**10** Model: LDT, LHT 036H - 072H J VOLT HEATPUMP - EBM BLOWER WITHOUT HIGHER SCCR  
Voltage: 575V/3~60Hz (J)  
Supersedes: N/A Form No: 538202-01 Rev: 4

538202-01

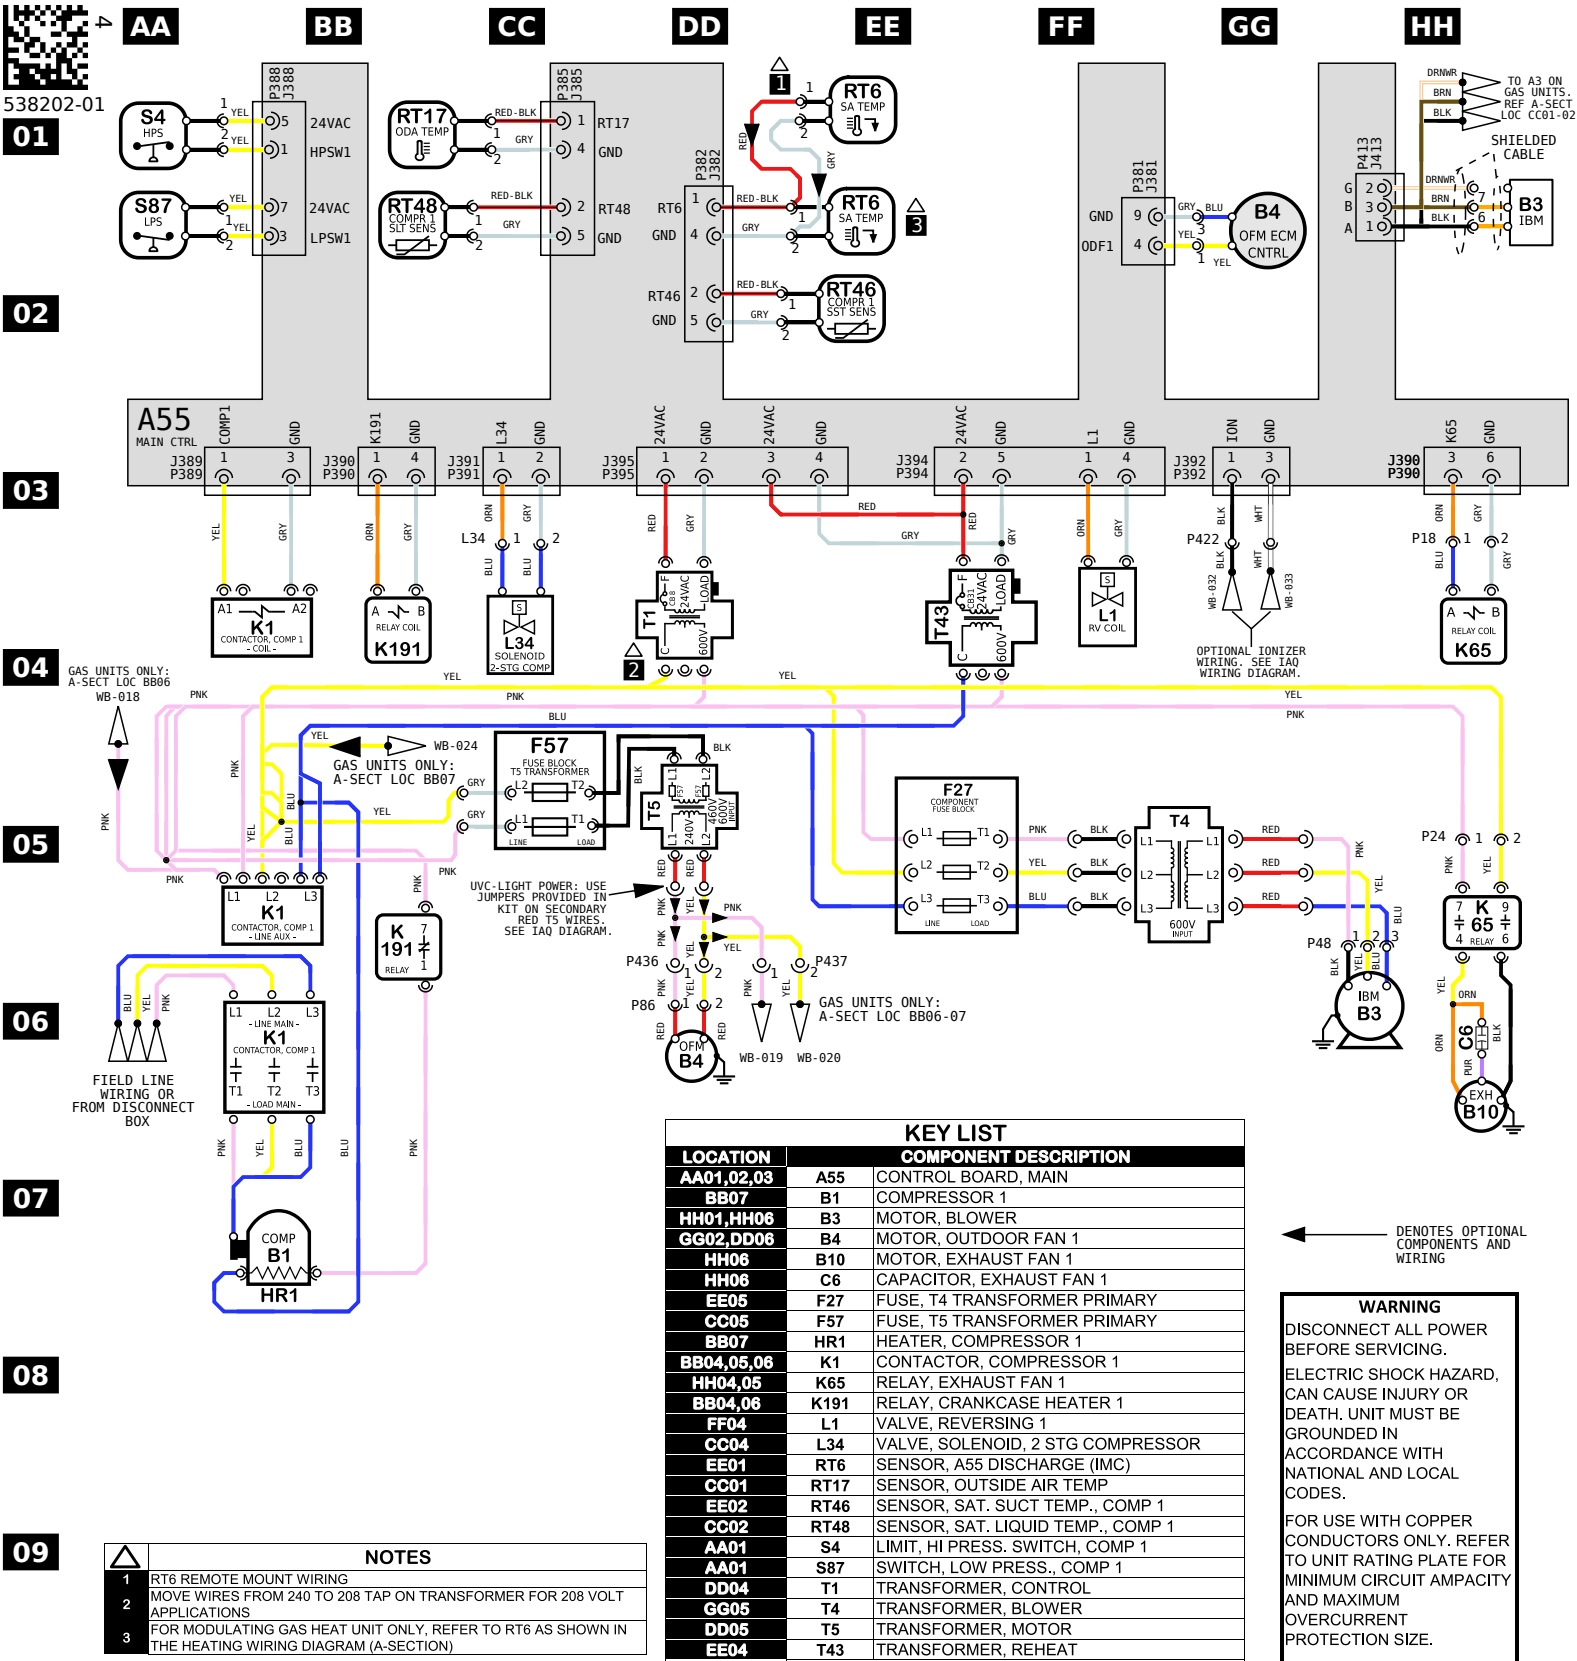
REV	EC NO.	DATE	BY	APVD	REVISION NOTE
--	CN-008852	06/01/2022	AXL	AAH	ORIGINATED AT PD&R CARROLLTON, TX
003	CN-014014F	1/6/2026	ZN	AWH	A) CLEANED UP WIRES TO GAS SECTION (A-SECT)
004	CN-013731A	3/3/2026	ZN	HMT	A) ADDED NOTE 3 FOR MODULATING GAS HEAT
